LETTER REPORT ON
ADVANCED PLANNING
OF
THJORSA DIVERSION FEATURES

BURFELL PROJECT

PREPARED FOR
THE STATE ELECTRICITY AUTHORITY
GOVERNMENT OF ICELAND
MAY 1963

Subject: Burfell Project
Thjórša Diversion
Features

GEOLOGIC MAP-PROJECT AREA
SHEET 2 OF 2

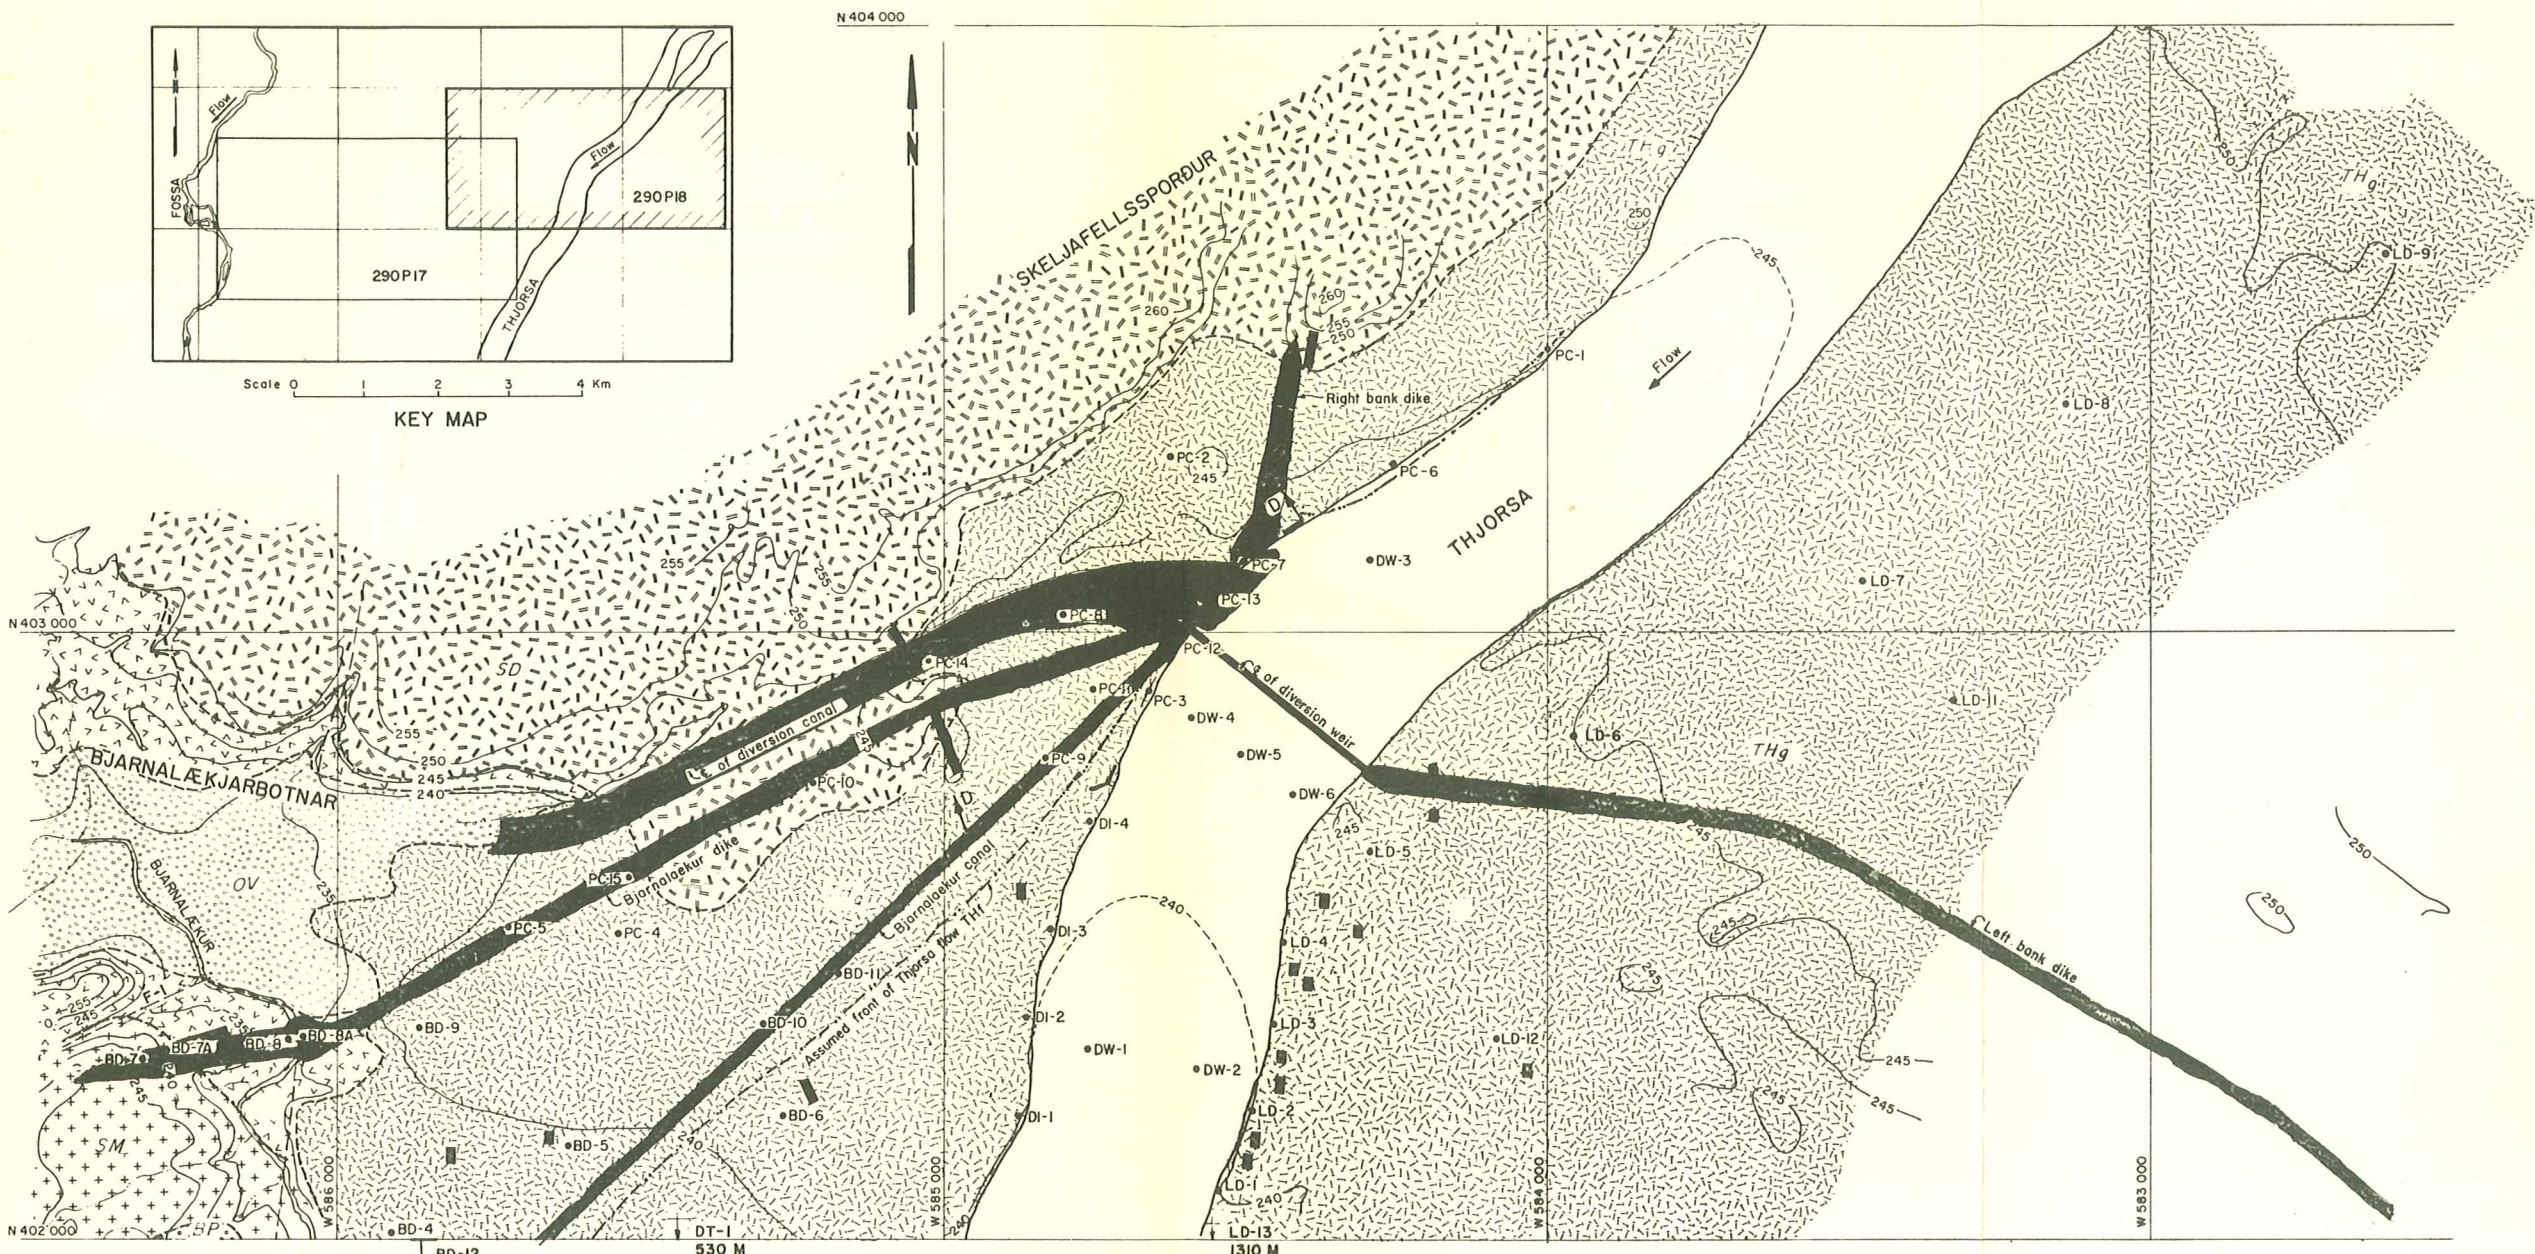
The logs of these seven core borings are shown on revised Exhibits B-14 and B-15 of Appendix II of the Planning Report. The log of Drillholes PC-8 and BD-4 were also corrected with respect to elevations only. The location of the three new borings are shown on Exhibit R-12, Sheet 2 of 2, which represents a revision of Exhibits 12 and B-4, Sheet 2 of 2, of the Planning Report.

THE STATE ELECTRICITY AUTHORITY ICELAND		
BURFELL PROJECT		
DIVERSION STRUCTURES GENERAL PLAN		
HARZA ENGINEERING COMPANY INTERNATIONAL		
PREPARED BY HARZA ENGINEERING COMPANY		
APPROVED <i>AP Leuss</i>		
CHICAGO, ILLINOIS	DATE APRIL 1963	DWG. NO. 290 P73

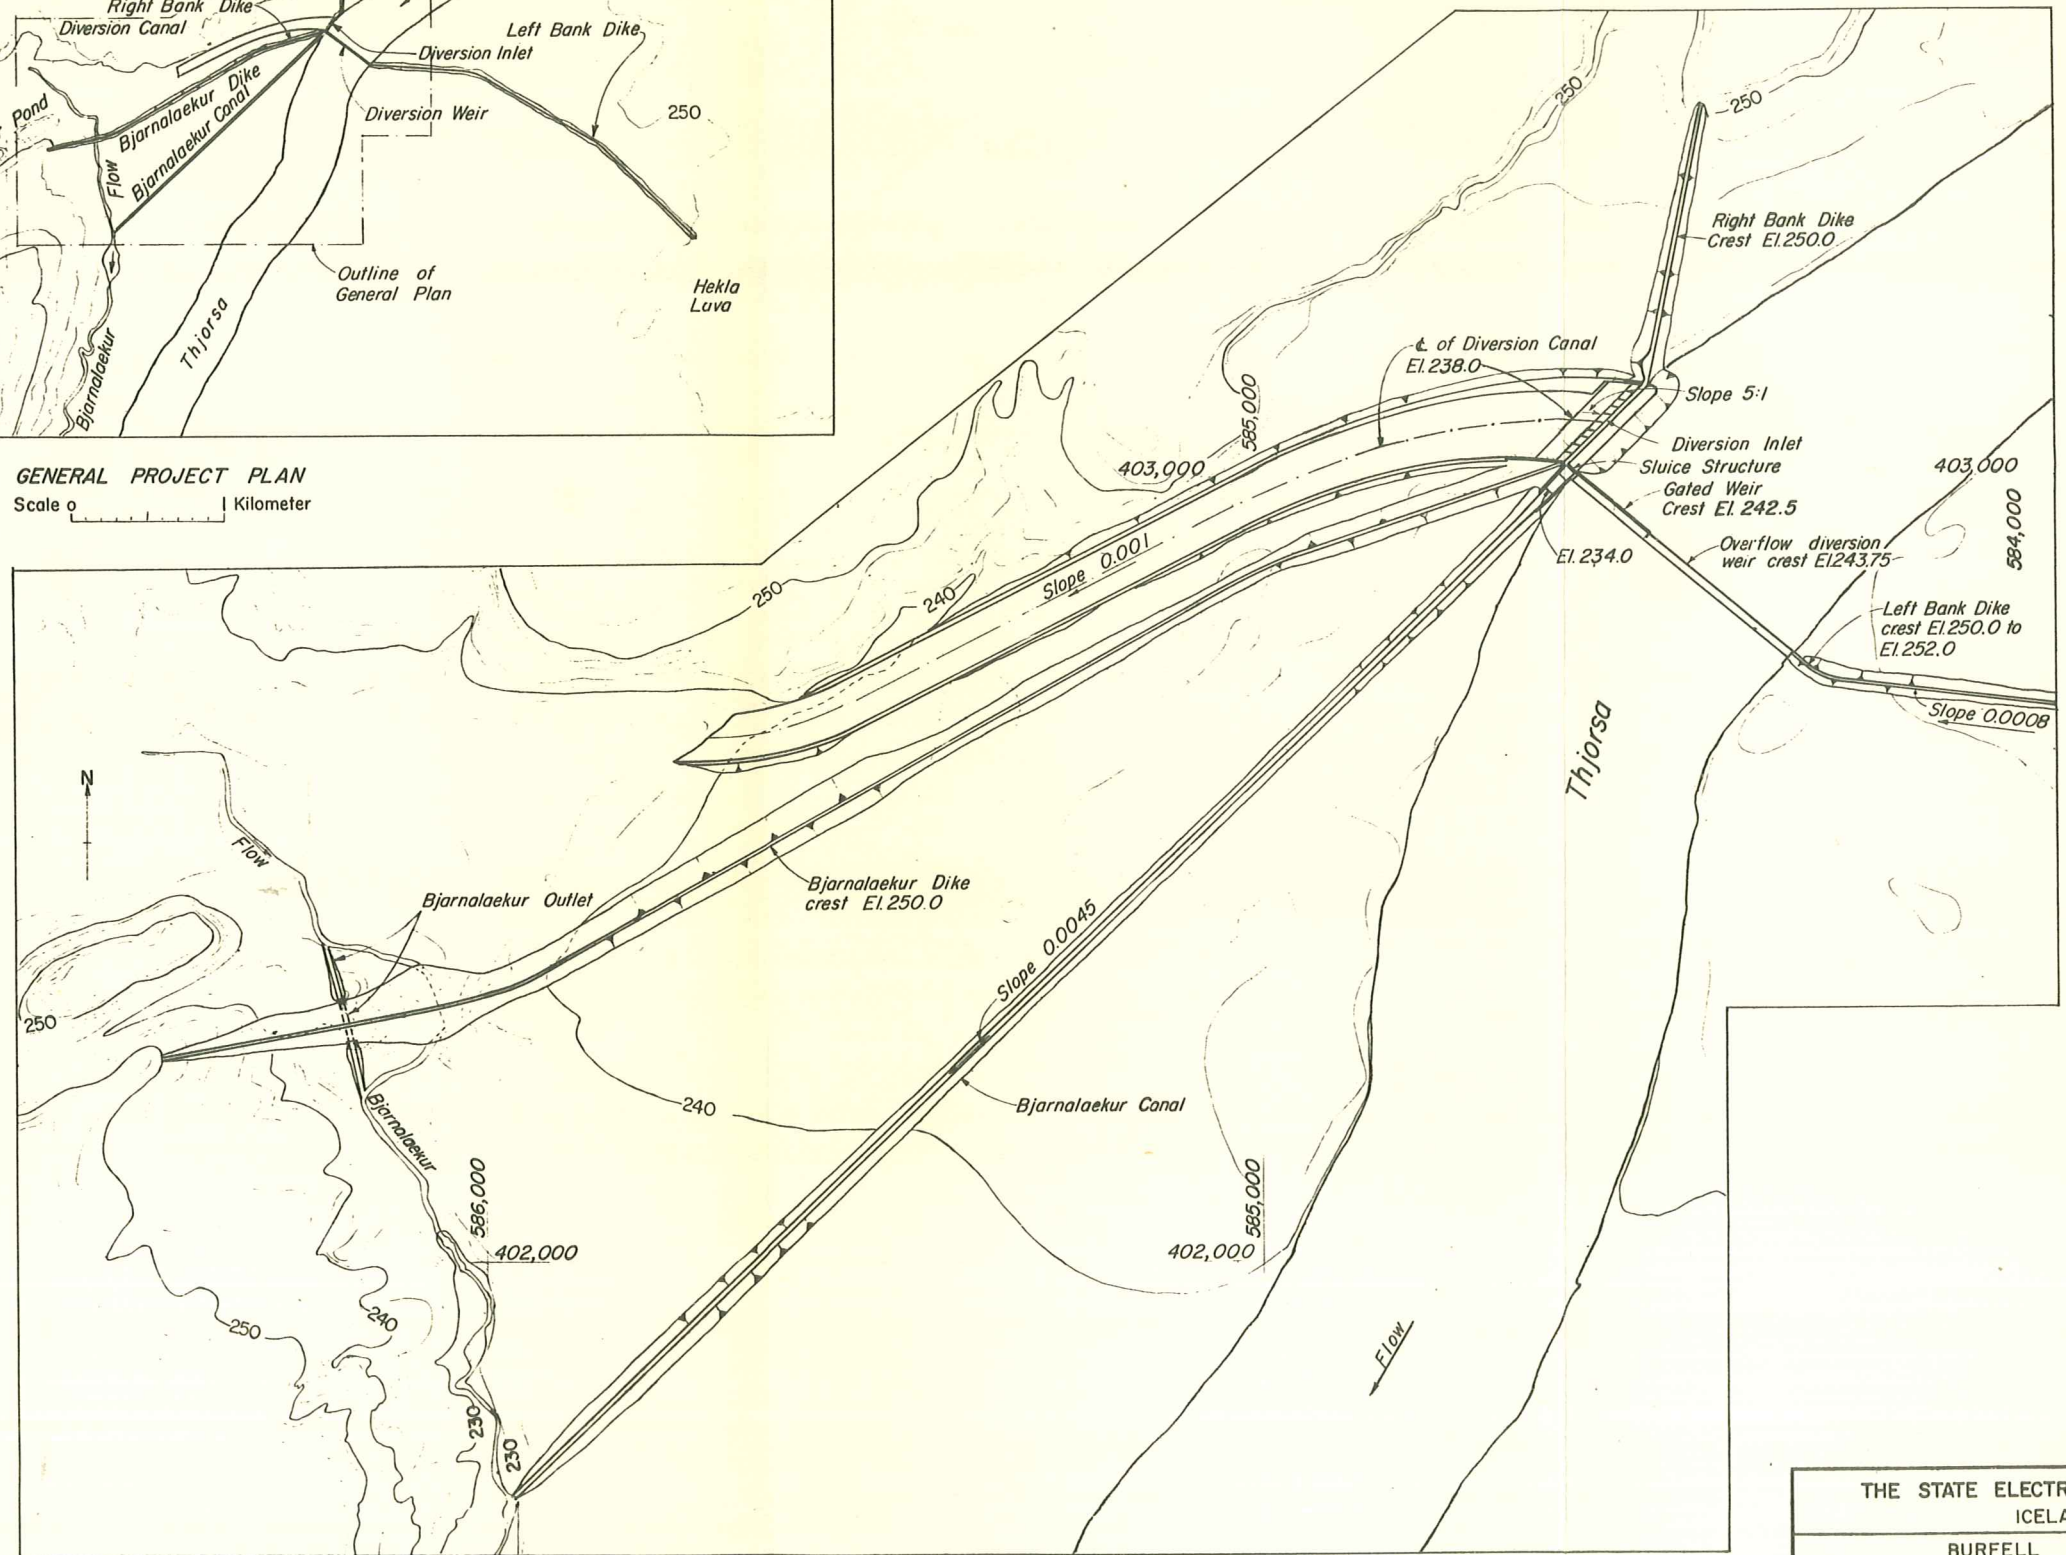
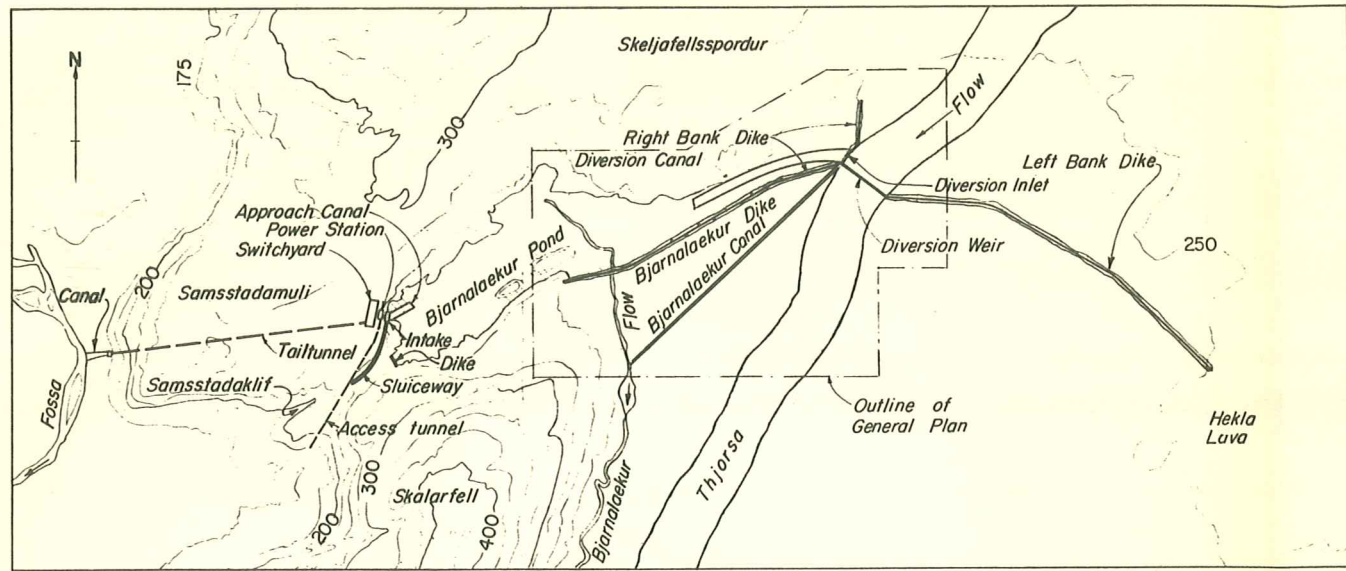
In addition, there were a number of more minor design changes required to fit in with these major changes. In general, the Thjorsa Diversion Features can be considered as virtually redesigned. The relocated and redesigned Thjorsa Diversion Features are shown in plan on Exhibit R-14A. Each of the changes is discussed in detail below. In part, these new designs were based on additional field investigations accompanied by required further evaluation of the previous field information. These field investigations were accomplished in March, 1963.

Inasmuch as the potential still exists for ice jams to form at these points with diversion of waters to the Ytri-Ranga, it was decided to relocate the Left Dank Dike to extend eastward from the Diversion Weir to the front of a Hekla lava flow as shown on Exhibit R-14 A. This Dike will force overflow waters to return to the Thjorsa upstream of the Diversion Weir. The location of the Dike was established by map and field reconnaissance. This was followed by topographic profiling of the proposed alignment. Thereafter a power auger was used to determine the thickness of the sand and lapilli overlying the top of the Thjorsa lava.

The moving of the river structures upstream from the location shown in the Planning Report required shifting of the Diversion Canal to the location shown on Exhibit R-14A. The location was selected in order to provide the minimum amount of rock excavation and also to permit placing as much of the Bjarnalækur Dike as feasible on the older basalts which are far less permeable than the Thjorsa lavas. The rock excavation was held to a minimum because of the plentiful availability of rock from other required excavations to assure

The base width of the Canal at grade will be about 88 meters immediately downstream of the Inlet Structure. The base width will be gradually narrowed to become 60 meters as a point about 450 meters downstream from the Inlet. No rock excavation is required in front of the right two bays of the Inlet, except for possibly a minor amount to smooth flow conditions. However, the overburden will be removed from downstream of these two bays as shown by the plan of Exhibit R-14A.

The Right Bank Dike was relocated and shortened from the location proposed in the Planning Report to the location shown on Exhibit R-14A. The profile and section are shown on Exhibit R-14B. The crest will be level at elevation 250. The Dike is required only to prevent Thjorsa flood waters from carrying sediment into the Bjarnalækur Pond, and to dewater the Pond. Accordingly, the core is only carried to elevation 246 which assures that unwatering can be accomplished during all except very extreme flood periods. The core will tie to the curved concrete wall extending 40 meters upstream from the Diversion Inlet. Rockfill will be placed on the downstream side of that wall in order to form a turn-around for vehicles crossing the deck of the Inlet.
